8602180063 860213
PDR ADDCK 05000529
P PDR

NO SIGNIFICANT HAZARDS CONSIDERATION DOCUMENTATION

Unit 2 Technical Specification 3/4.1.2.2

FIGURE 6.2-1

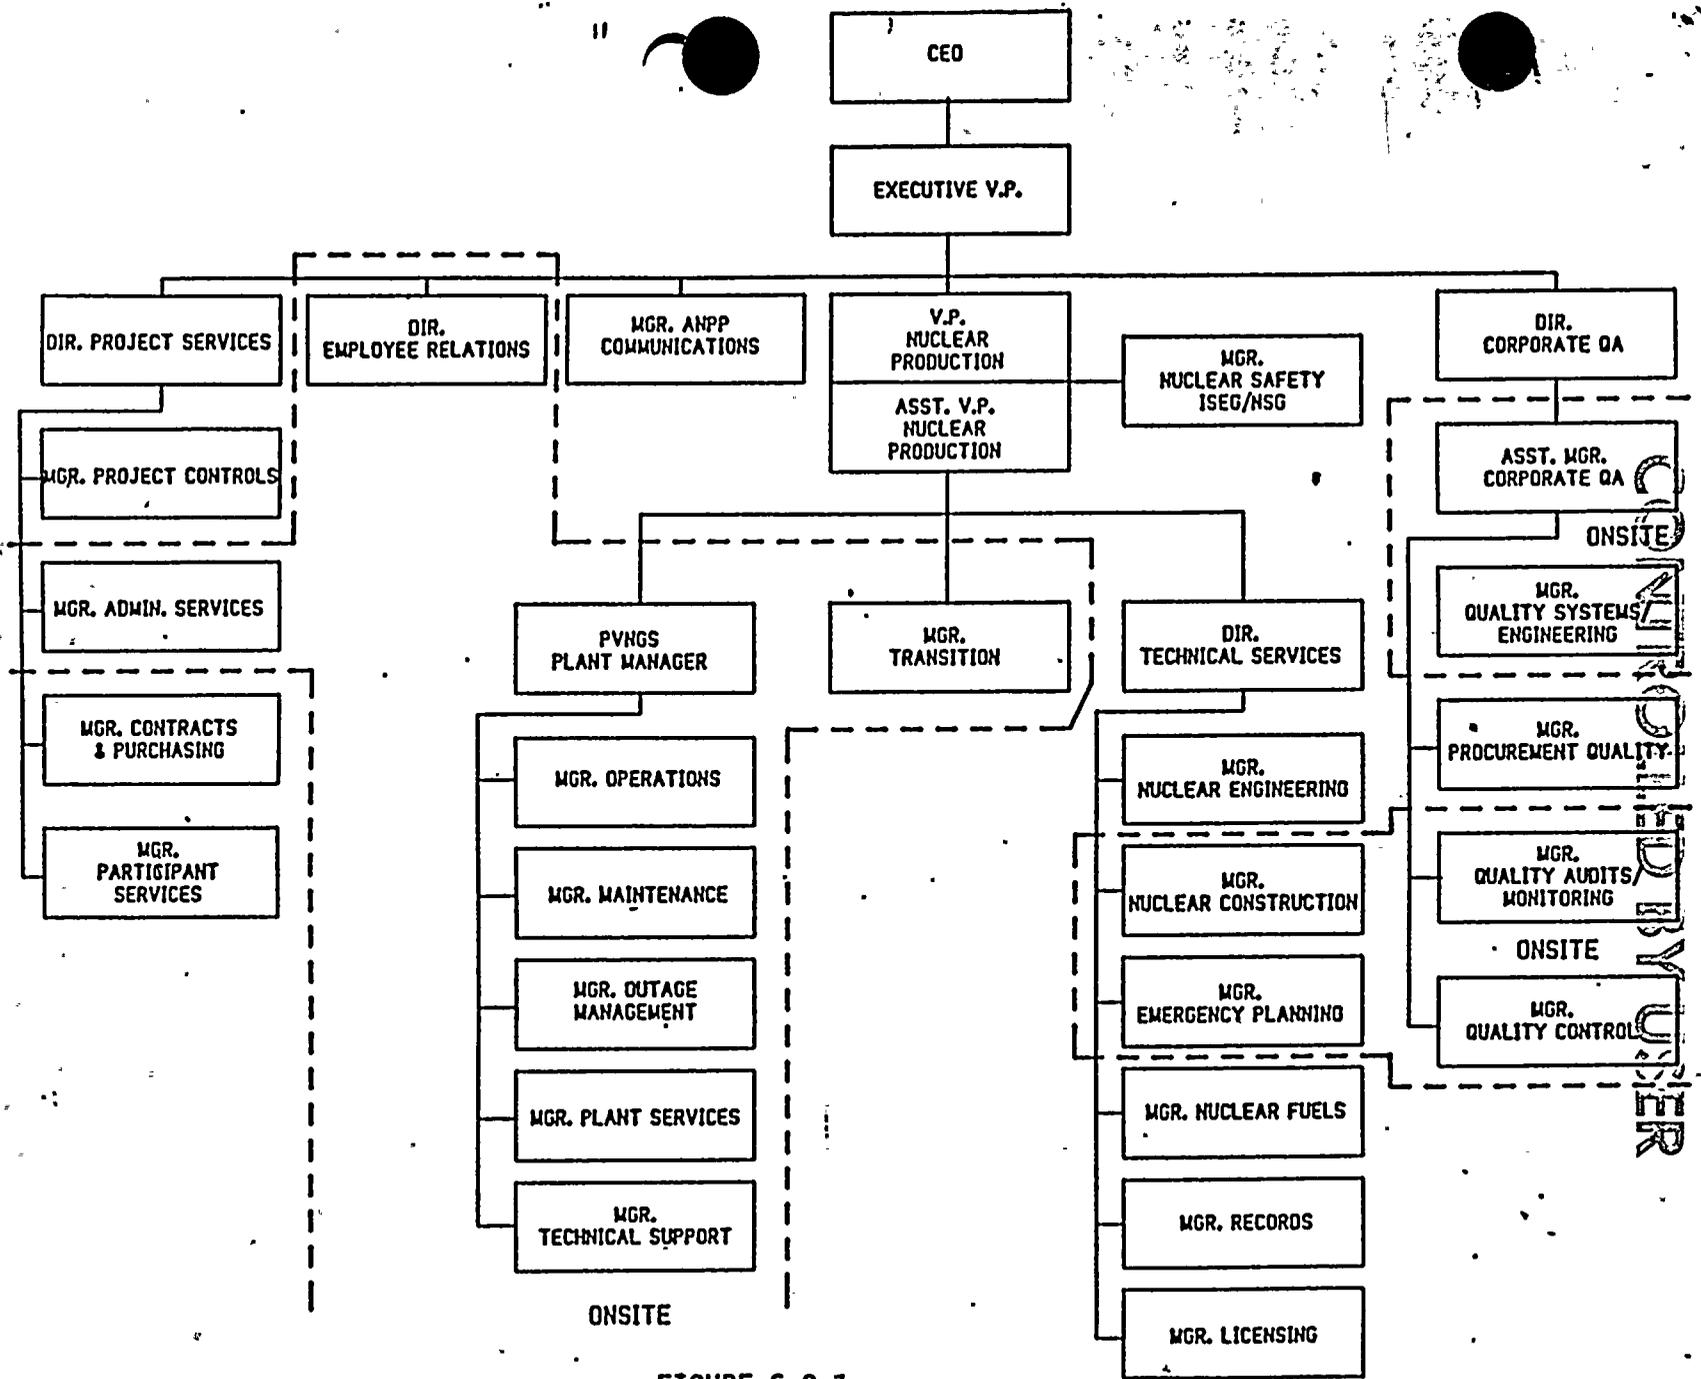
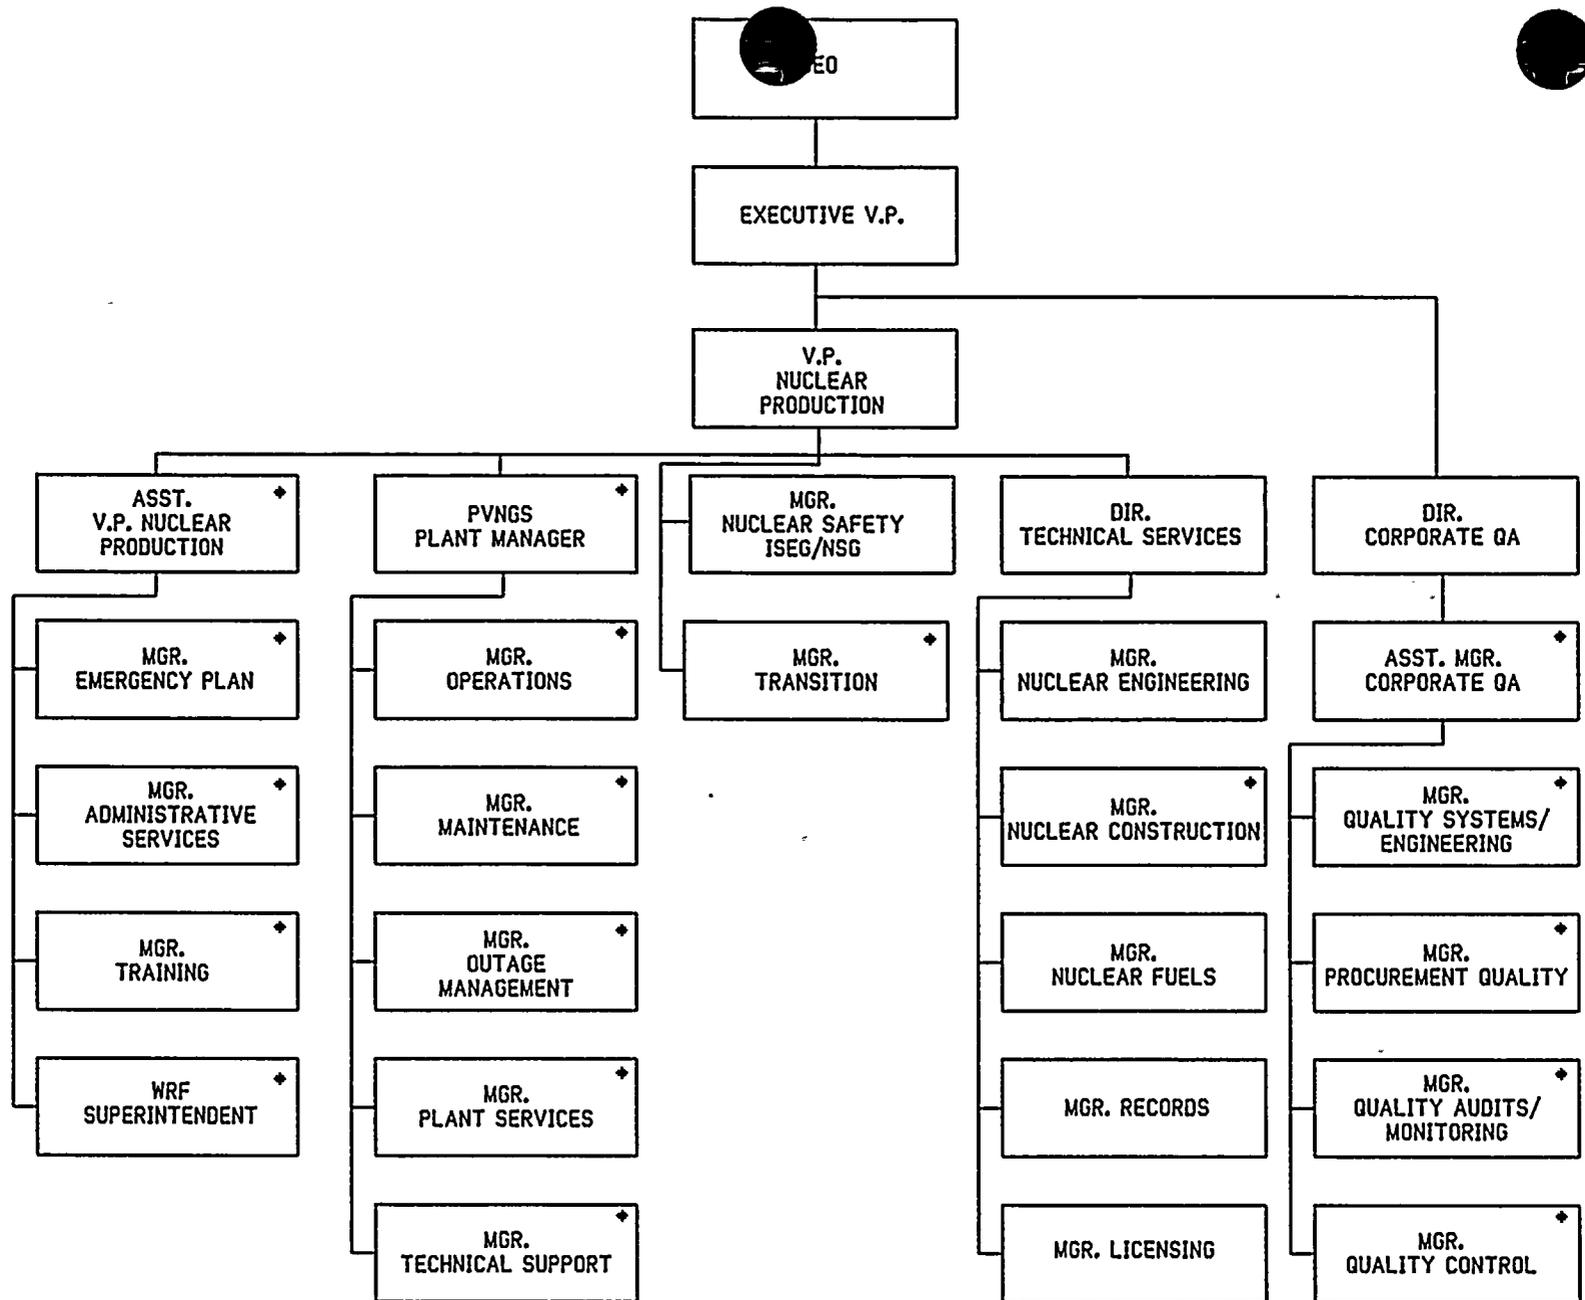
The revised organization charts reflect pending changes in the Arizona Nuclear Power Project organization.

FIGURE 3.1-1
 ALLOWABLE MTC MODES 1 AND 2
 PALO VERDE UNIT 2 CYCLE 1

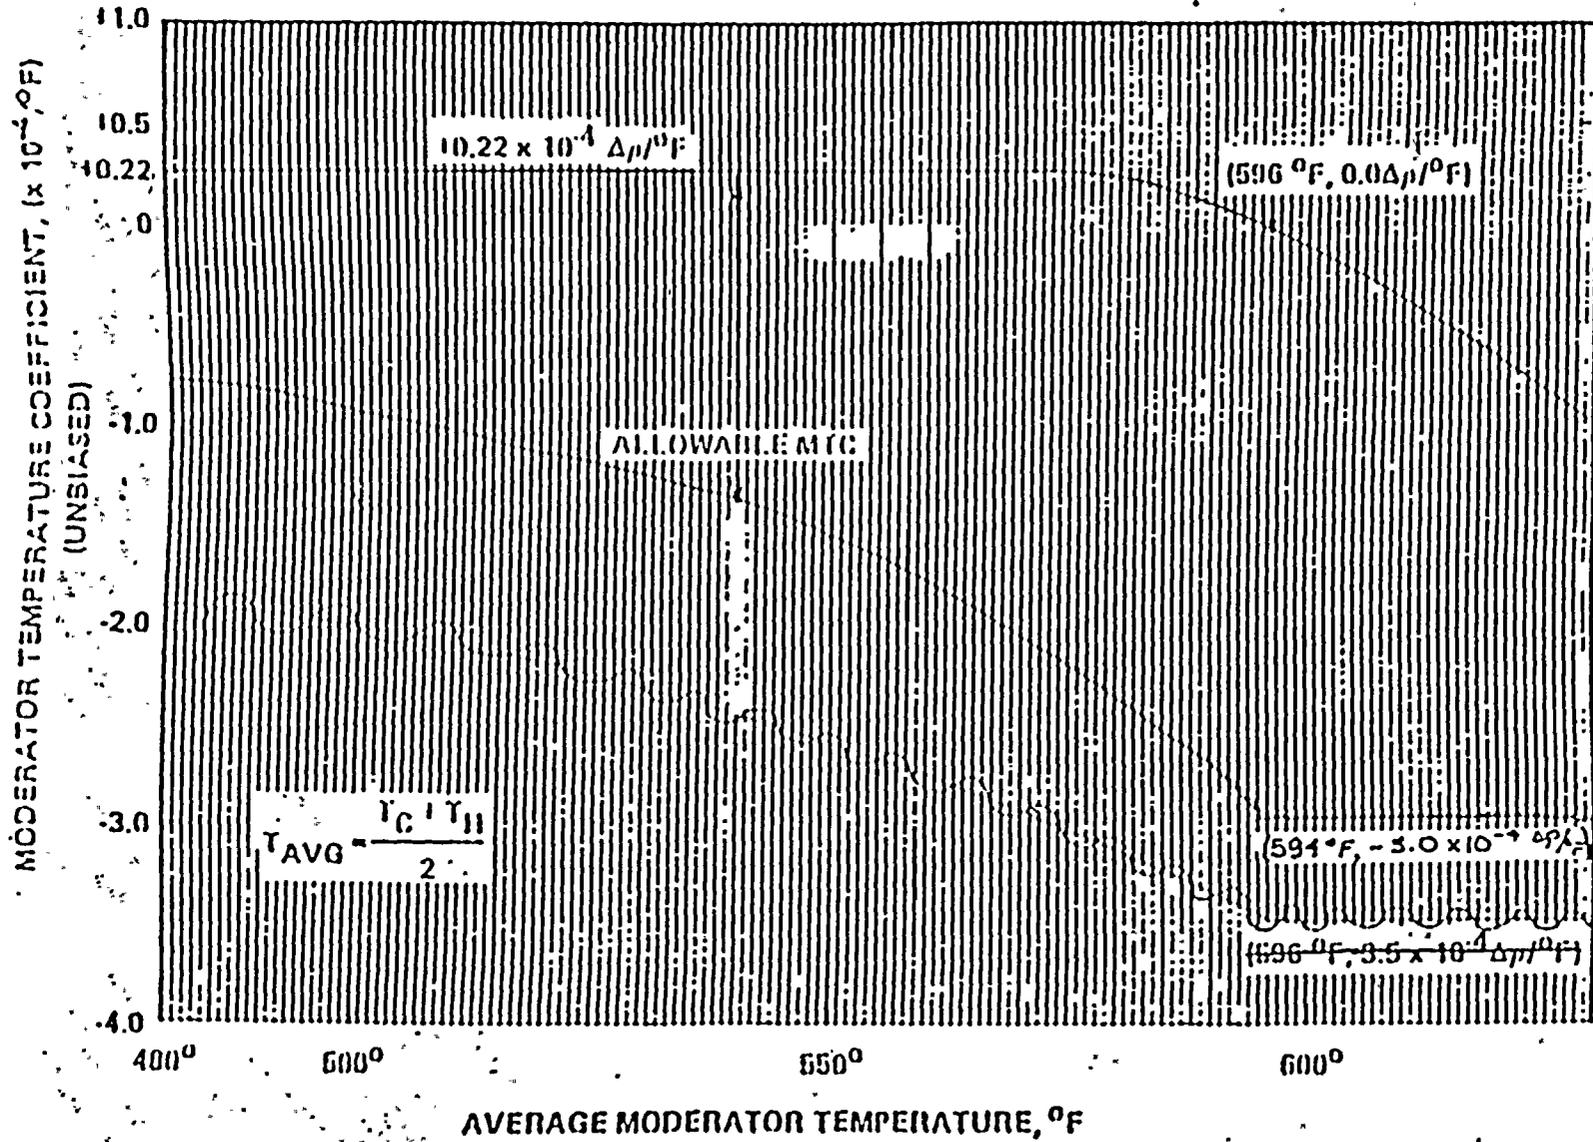
The proposed change revises Technical Specification 3.1.1.3, Moderator Temperature Coefficient. Technical Specification 3.1.1.3 establishes the range of allowable moderator temperature coefficient (MTC) values as a function of average moderator temperature. MTC expresses variation in moderator reactivity per unit change in moderator temperature.

Technical Specification 3.1.1.3 is required to assure that actual (measured) values of MTC occurring during Unit 2 Cycle-1 are bounded by values assumed in the safety analyses. The proposed change revises the most negative value of MTC (appearing on Figure 3.1-1) from $-3.5 \times 10^{-4} \Delta p/^{\circ}\text{F}$ to $-3.0 \times 10^{-4} \Delta p/^{\circ}\text{F}$.

FIGURE 3.4-2
RCS PRESS/TEMP LIMITS
CONTROLLED BY USER

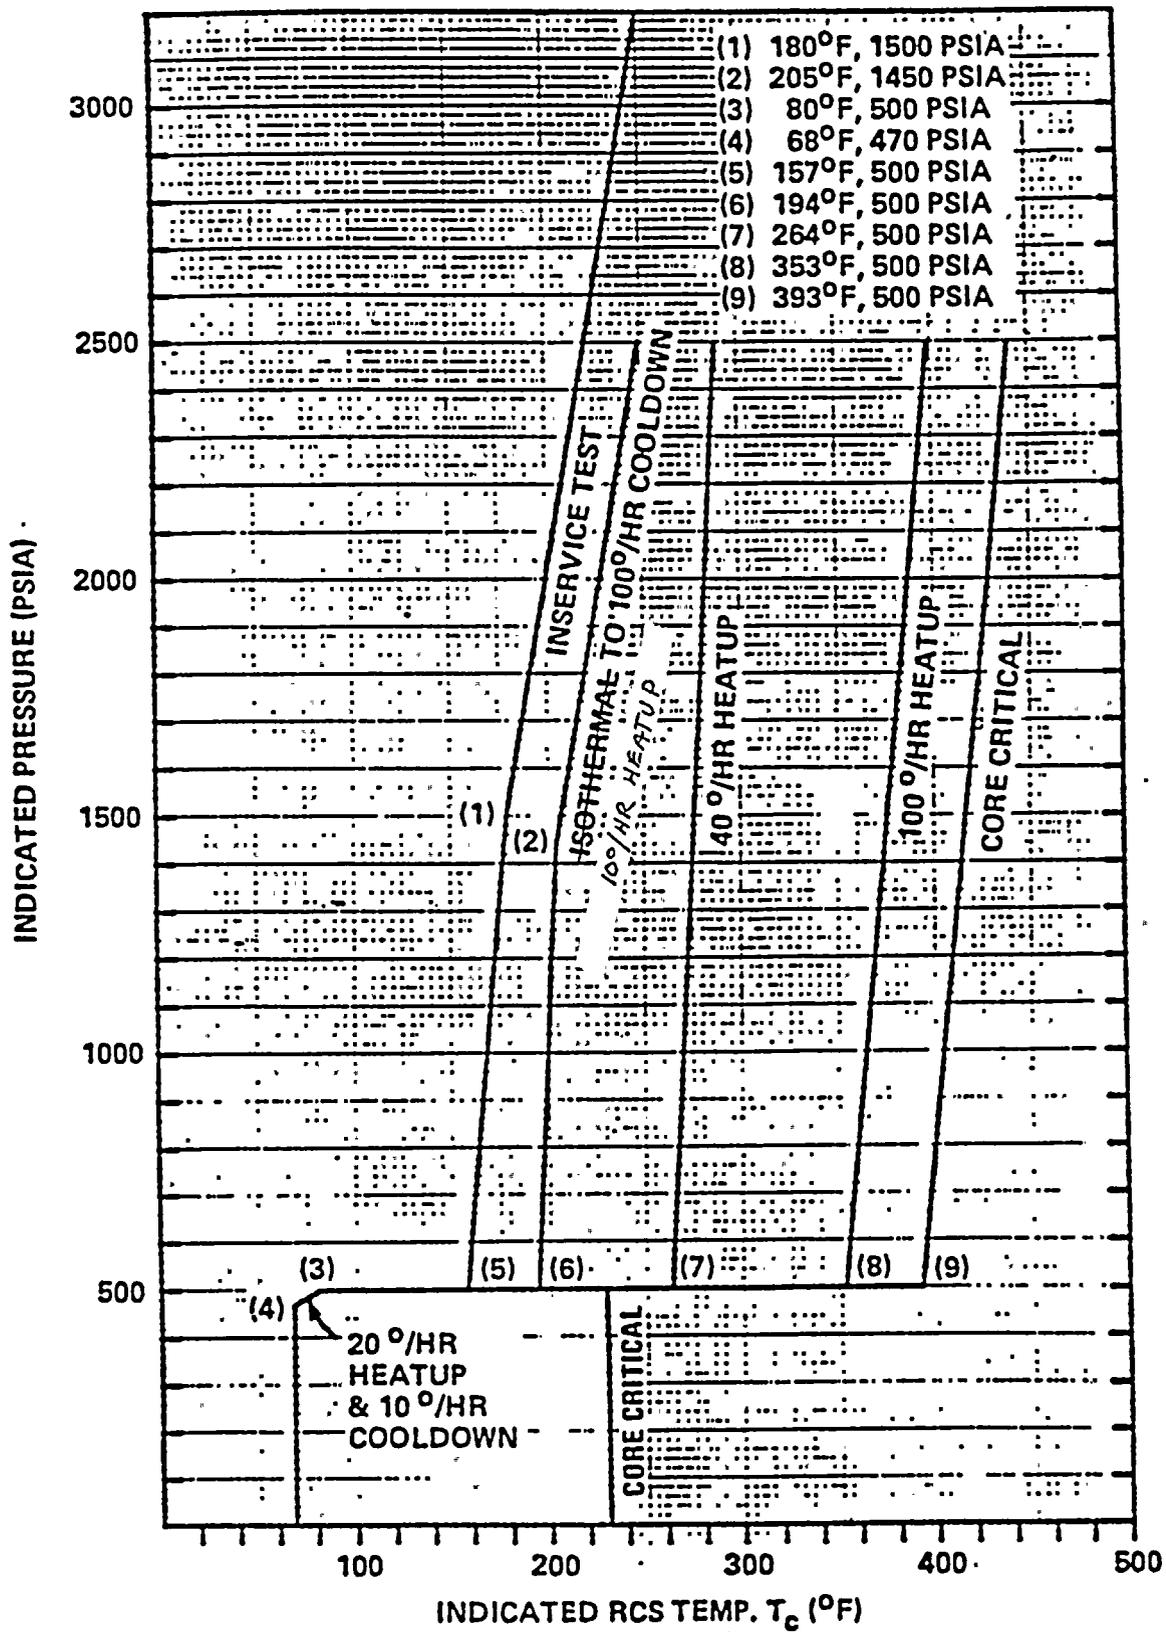
This change is made in conjunction with the change to specification 3/4.4.8.3. Re-examination of the pressure/temperature analysis shows that the isothermal to 100°F hr. cooldown curve (Fig. 3.4-2) also encompasses the 10°F/hour heat up rate.

This change will allow the change to be made to specification 3/4.4.8.3 and both changes should be reviewed concurrently.
